**Subject: April 2012 Inspection Report
Cameco Resources, Permits 603 & 633**

APRIL 2012 INSPECTION REPORT

PERMITS 603 & 633

Figure 1 Disturbance to ephemeral drainage during well construction

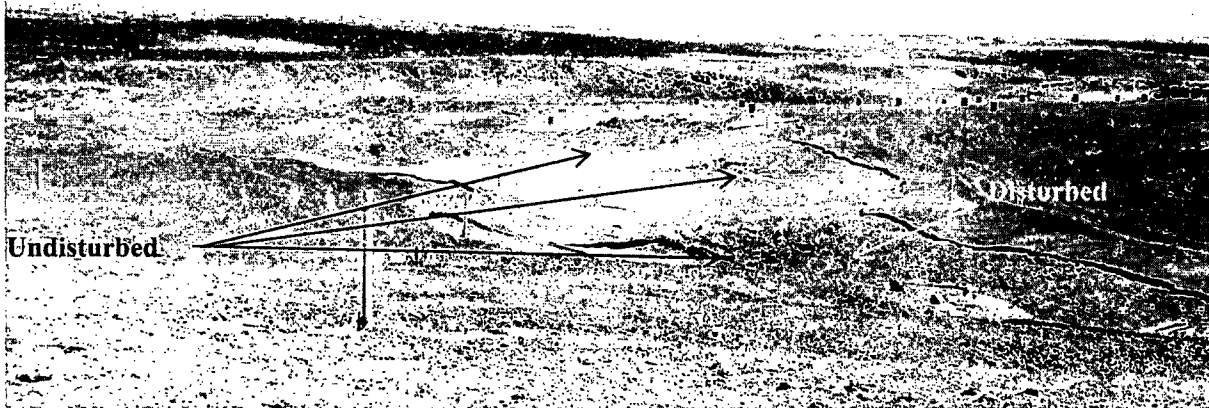
During the well completions inspection, it was noted that the surface disturbance to ephemeral drainages during well construction is significant. Although the drainages may not require designs for reconstruction (as when mining occurs through a drainage under surface mining of other resources i.e., coal, hard rock mines, etc., a large area of disturbance results from well installation (**Figure 1- 3**).

Figure 5 Sediment accumulation in front of culvert covered with tumbleweed.

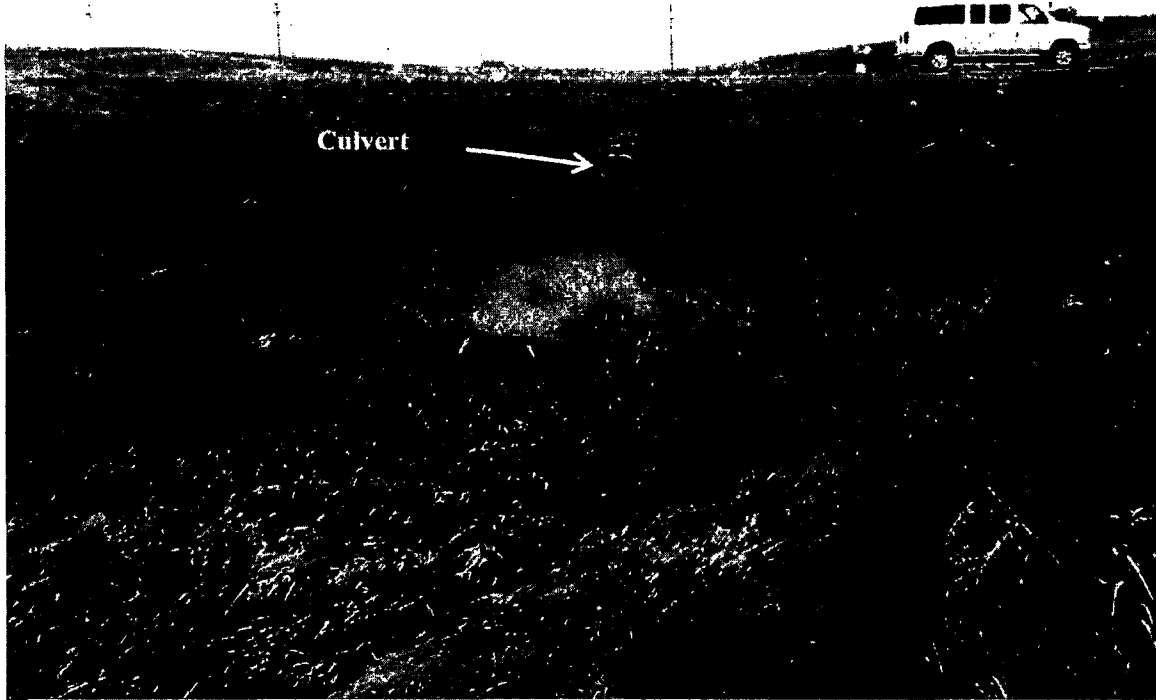
A second road crossing located north of Satellite SR-2 also has sediment deposition surrounding the culvert inlet. It may be accumulation from the road or the result of poor maintenance of the sediment controls upstream. The culvert is covered with tumble weed (**Figure 5**).

LQD will be paying close attention to the efforts to maintain the accomplishments that were established with the former reclamation specialist position. **Please conduct all required maintenance on sediment controls and topsoil protection features. LQD will continue to conduct inspection for maintenance of these structures.**

Figure 6 View of constructed road access to water supply pond outside the permit boundary

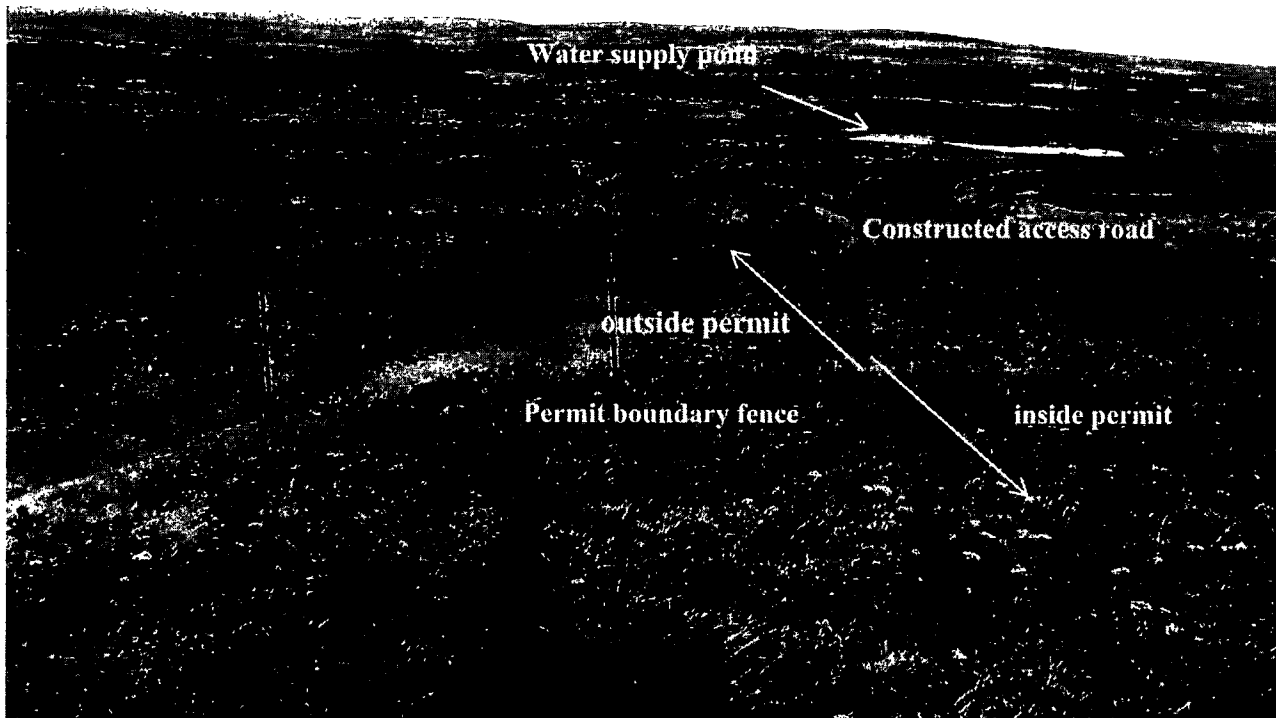
Pattern Area for HH-1 included many wells installed, however, due to proximity to the permit boundary CR needs to amend lands to complete the pattern. This has not happened due to stalled land acquisition issues to propose an amendment. An improved access road has been constructed which is used to access a water supply pond located outside the permit boundary (**Figures 6, 7 & 8**). In addition, two monitor wells and a third well of unknown usage that had inadequate capping were discovered outside the permit boundary (**Figures 9, 10 & 11**). CR stated the monitor wells were used to establish baseline for Wellfield-9.

- LQD Noncoal Rules and Regulations, Chapter 11, Section 6(b)(ii) for insufficient cover of the wells
 - An improved road to the water supply pond is in violation of:

- WEQA § 35-11-405(a) for construction activities related to mining outside the permit

Figure 7 View of water supply pond

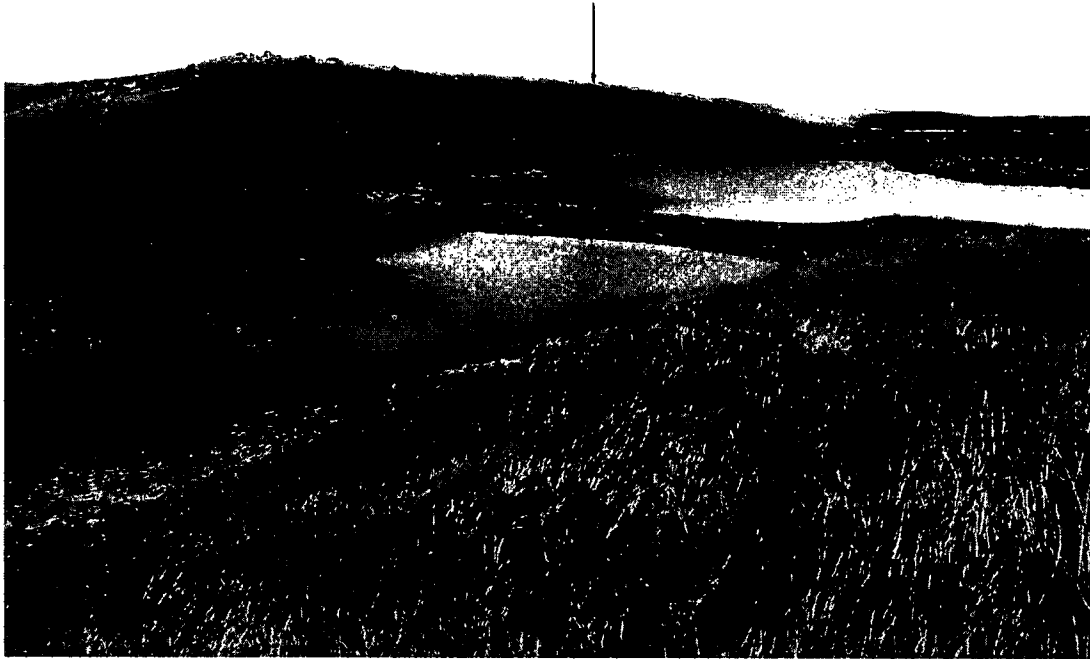
A water supply pond outside the permit boundary is in violation of:

- WEQA § 35-11-405(a) for construction activities related to mining outside the permit,
- LQD Noncoal Rules and Regulations, Chapter 11, Section 4(a)(iv) for lack of approved plan and design for the pond in the permit and,
- WEQA § 35-11-406(b)(xiv) for unapproved use of water in mining related activities.
